City of Santa Fe, New Mexico

DATE: October 28, 2025
TO: Historic Districts Review Board Members
VIA: Heather Lamboy, Planning & Land Use Department Director #LL
Maggie Moore, Assistant Land Use Director *MRM*
Gary Moquino, Historic Preservation Division Manager GM
FROM: Lani McCulley, Senior Planner, Historic Preservation Division *LJM*

2025-011228-HDRB, 927 Canyon Rd., Downtown & Eastside Historic District, non-contributing, Innovative Design Construction, agent for Joseph Gonzalez, owner, proposes to construct a 576 sq. ft. carport addition to a height of 10'-0" where the maximum allowable is 18'-1".

Figure 3: Carport Location

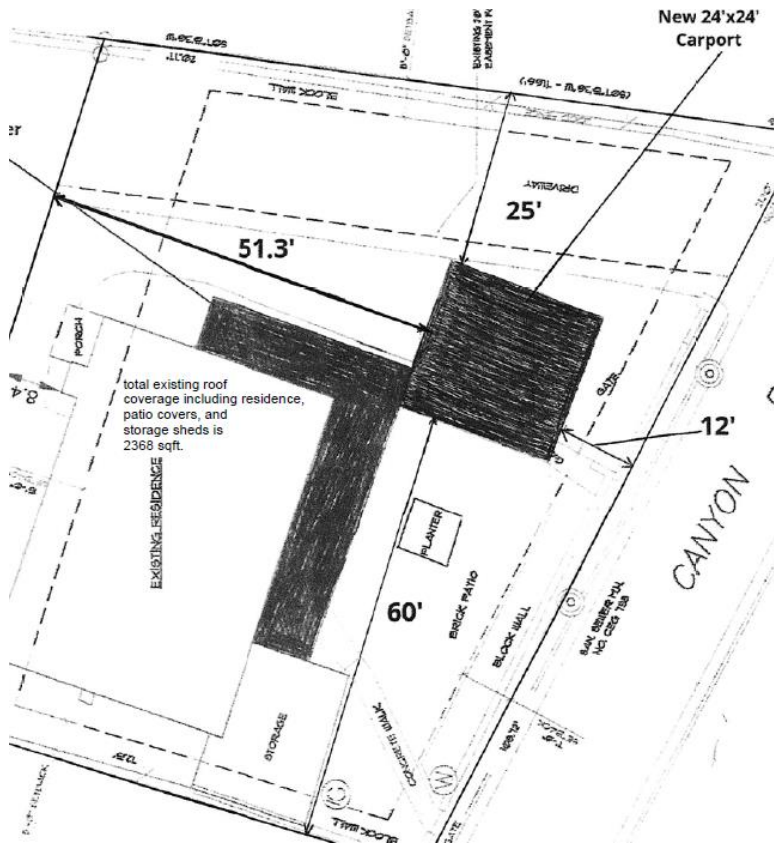
1. Construct a 576 sq. ft. carport addition to a height of 10’-0”, where the maximum allowable is 18’-1”. The carport will be located on the existing concrete parking pad and attached to the existing north portal roof in the southeast corner and will be open on all four sides. The framing will be painted light brown, and the roof will be TPO in a tan color.

Staff recommends approval of the proposed project and finds that the application complies with Section 14-5.2(D) General Design Standards for all Historic Districts, and 14-5.2(E) Downtown and Eastside Design Standards.
